PLANNING COMMISSION STAFF REPORT

DATE: April 9, 2014

SUBJECT: ED FREEMAN OF PINNACLE VIEW LLC, OWNER, FOR ARCHITECTURAL REVIEW OF THE LANDSCAPE PLAN AND RELATED FEATURES FOR THE COMMON AREAS OF THE DESERT PALISADES SPECIFIC PLAN, A DEVELOPMENT OF 110 HOMESITES ON 117 ACRES IN PLANNING AREA 4 OF THE ENVIRONMENTALLY SENSITIVE AREA – SPECIFIC PLAN (ESA-SP) ZONE (CASE 5.1154 SP / TTM 35540) (KL)

6. *Landscaping to screen and mitigate the visual impacts of the DWA water tanks that are part of the project.*

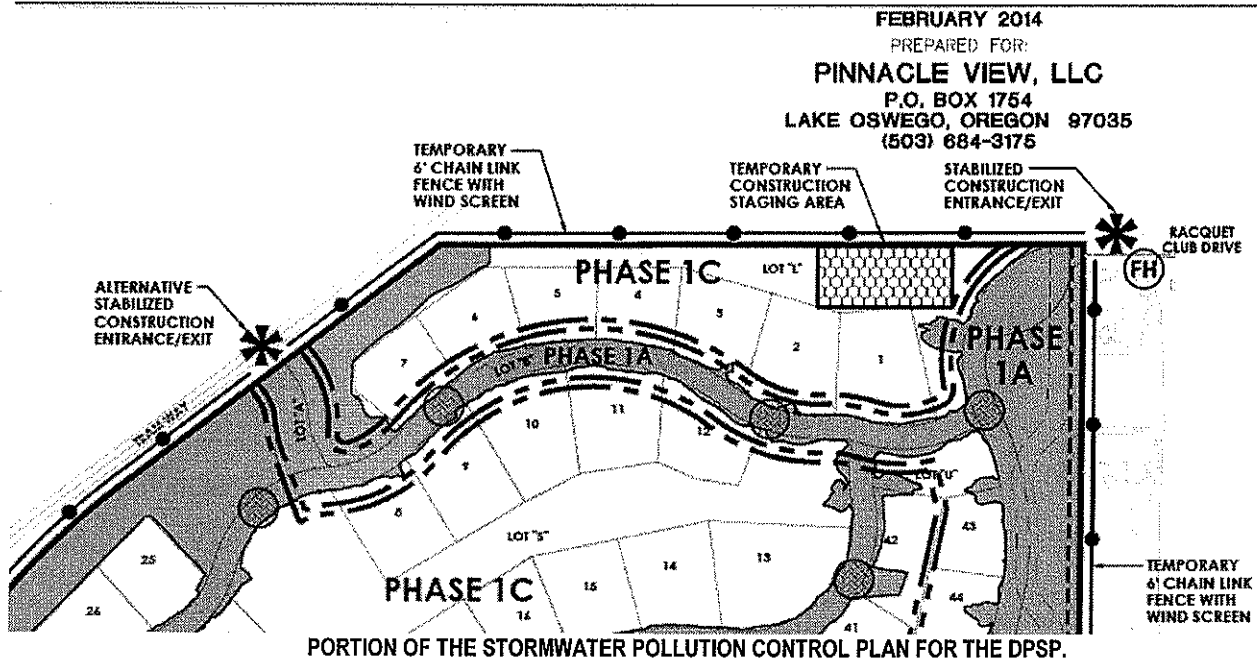
As noted in the Environmental Impact Report (EIR) for the DPSP, dated December, 2009, page 47, the project proposes two large Desert Water Agency storage tanks near the southwest corner of the project site. EIR Mitigation Measure MM 3.1-1(c) denotes “*The Desert Water Agency shall paint the sides of the reservoir an earth tone color to reduce the reflectivity and visibility from offsite vantage points. Landscape materials shall be introduced where practical around the tank to further reduce the visual impacts.*” The project proposes a grove of trees to be planted around the DWA reservoir tanks to partially screen and soften the appearance of the large, above-ground tanks. Tree species include a mix of 24 inch box ironwood, and Palo Verde trees.
